#### City of Albuquerque

RE: DRAINAGE PLAN FOR WESTWAY EXPRESS SHOP ADDITION (D-18/D10) RECEIVED MAY 6, 1993 FOR BUILDING PERMIT APPROVAL ENGINEER'S STAMP DATED MAY 11, 1991; AS REVISED MAY 5, 1993

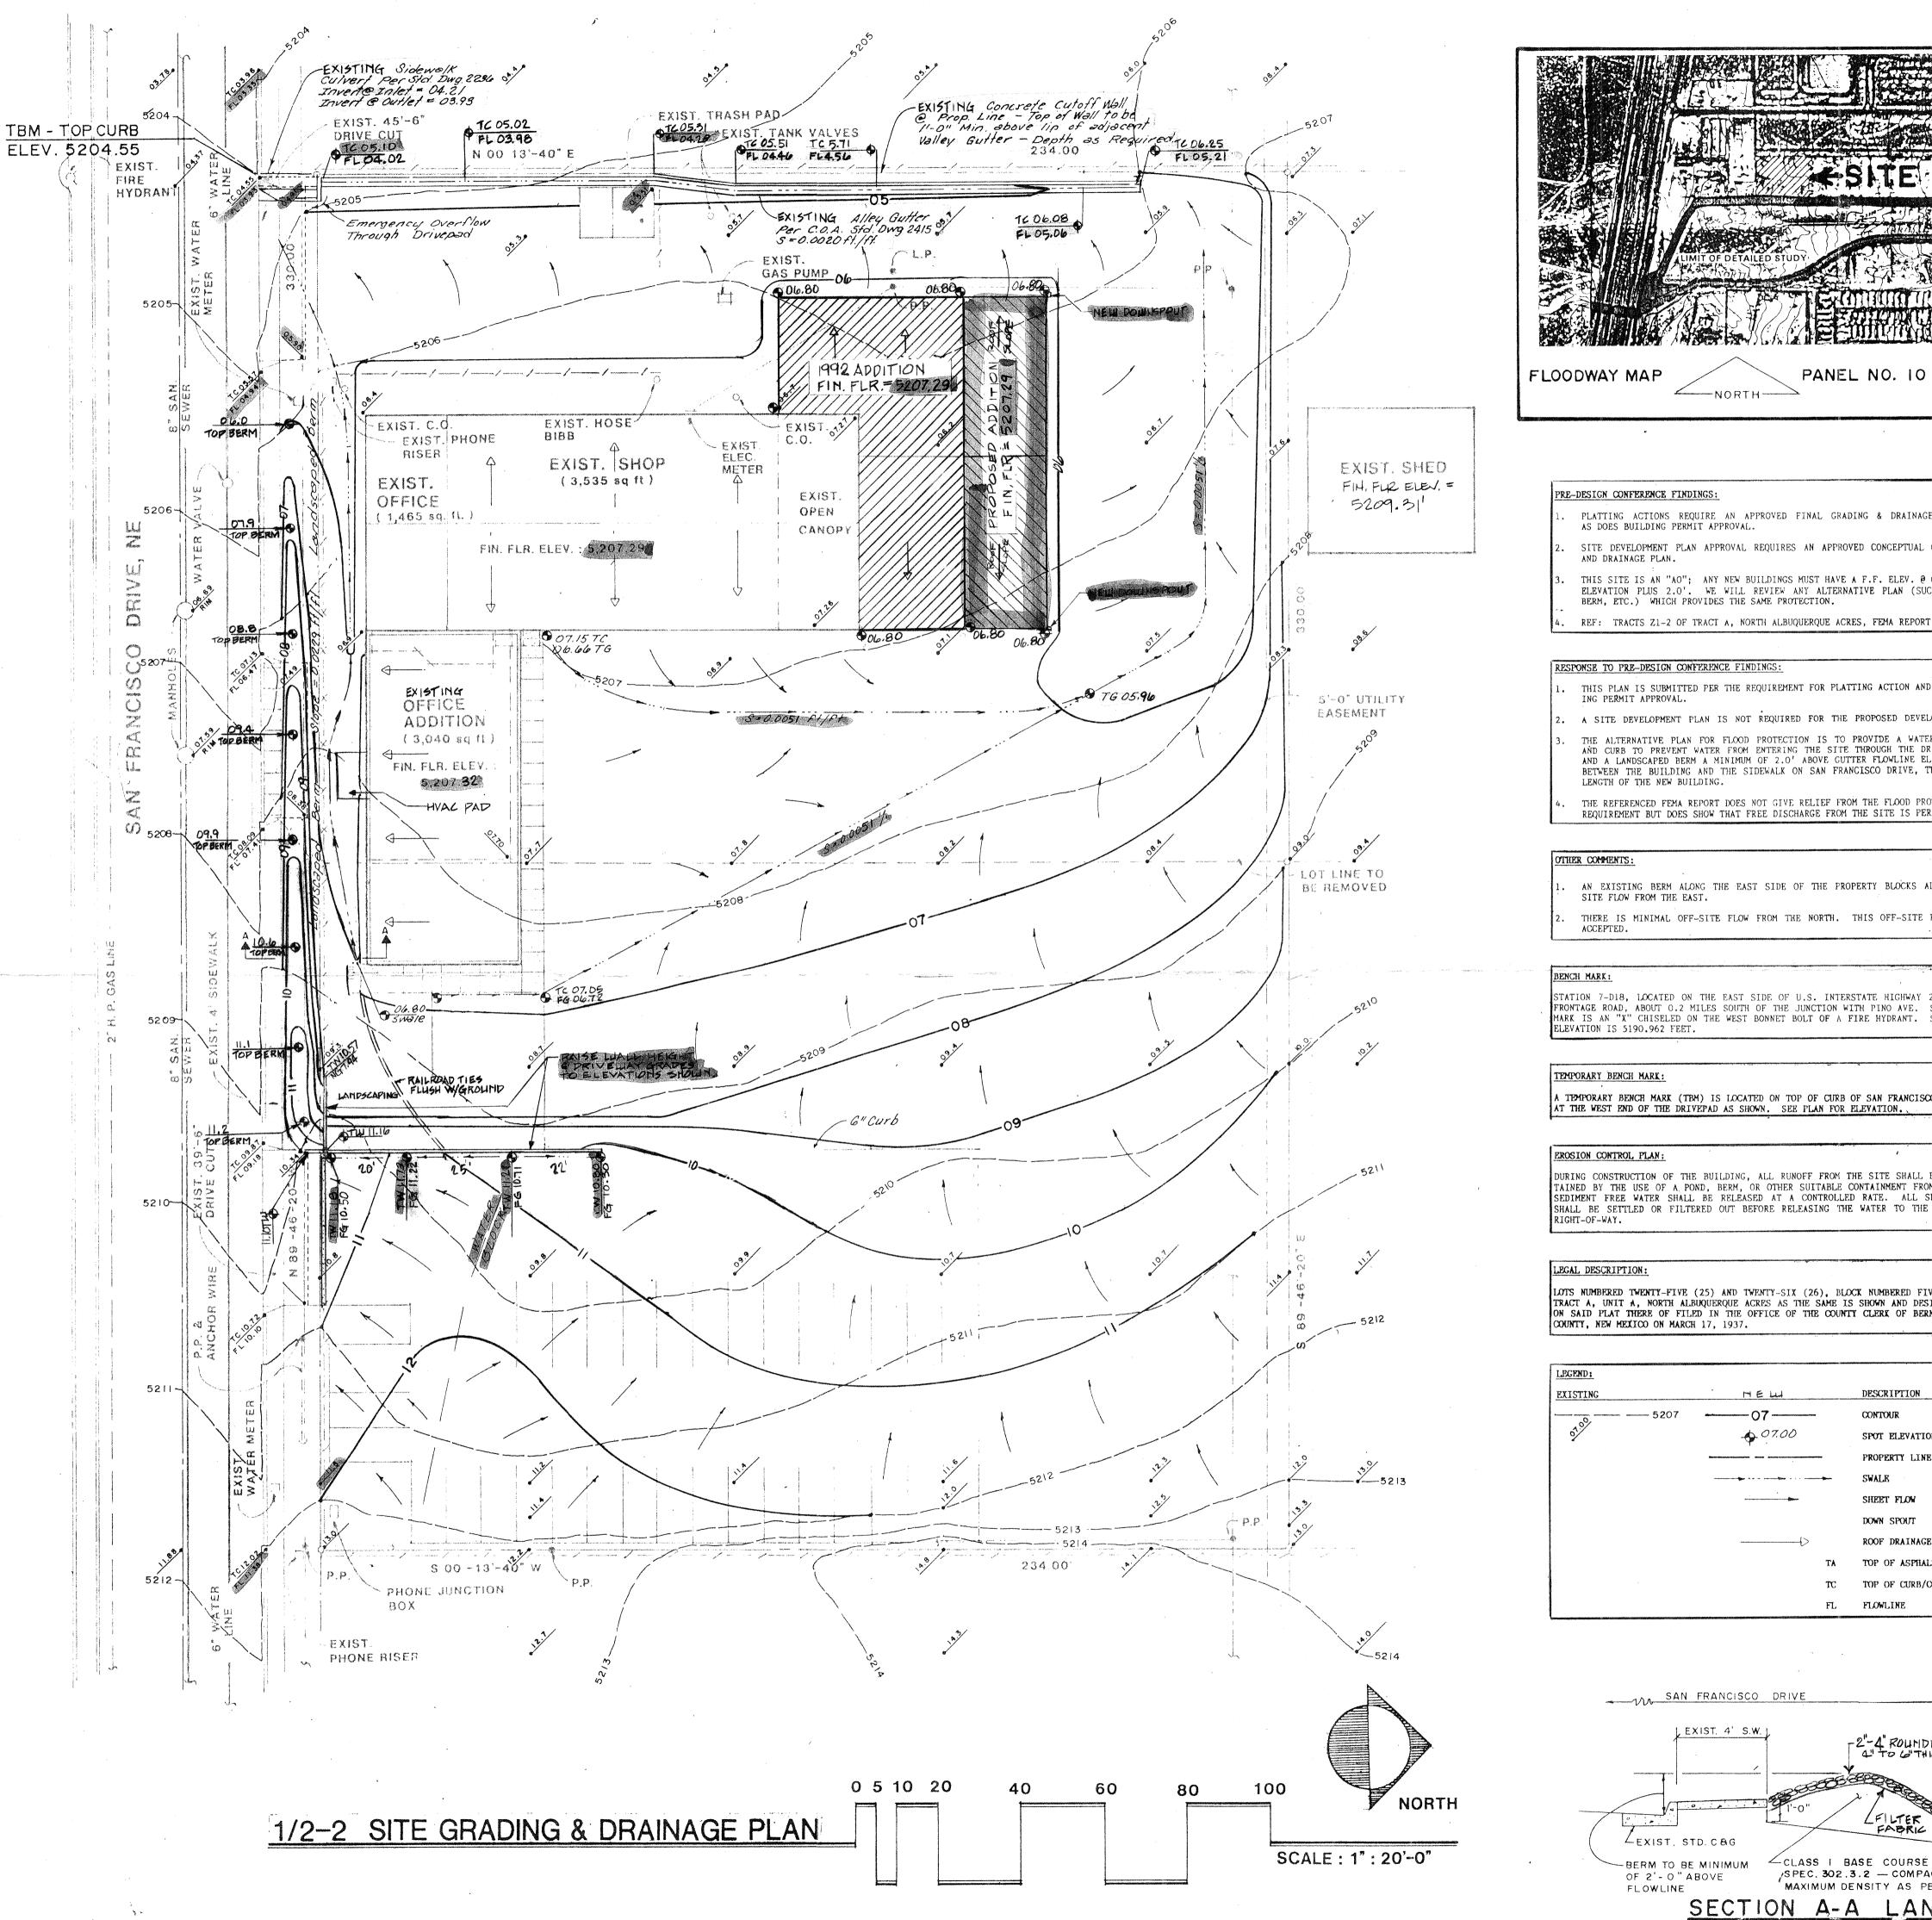
- PLATTING ACTIONS REQUIRE AN APPROVED FINAL GRADING & DRAINAGE PLAN, AS DOES BUILDING PERMIT APPROVAL. SITE DEVELOPMENT PLAN APPROVAL REQUIRES AN APPROVED CONCEPTUAL GRADING
- AND DRAINAGE PLAN. THIS SITE IS AN "AO"; ANY NEW BUILDINGS MUST HAVE A F.F. ELEV. @ GUTTER ELEVATION PLUS 2.0'. WE WILL REVIEW ANY ALTERNATIVE PLAN (SUCH AS A BERM. ETC.) WHICH PROVIDES THE SAME PROTECTION.

- THIS PLAN IS SUBMITTED PER THE REQUIREMENT FOR PLATTING ACTION AND BUILD-ING PERMIT APPROVAL.
- THE ALTERNATIVE PLAN FOR FLOOD PROTECTION IS TO PROVIDE A WATER BLOCK AND CURB TO PREVENT WATER FROM ENTERING THE SITE THROUGH THE DRIVEWAY; AND A LANDSCAPED BERM A MINIMUM OF 2.0' ABOVE GUTTER FLOWLINE ELEVATION BETWEEN THE BUILDING AND THE SIDEWALK ON SAN FRANCISCO DRIVE, THE FULL LENGTH OF THE NEW BUILDING.
- THE REFERENCED FEMA REPORT DOES NOT GIVE RELIEF FROM THE FLOOD PROTECTION REQUIREMENT BUT DOES SHOW THAT FREE DISCHARGE FROM THE SITE IS PERMITTED.
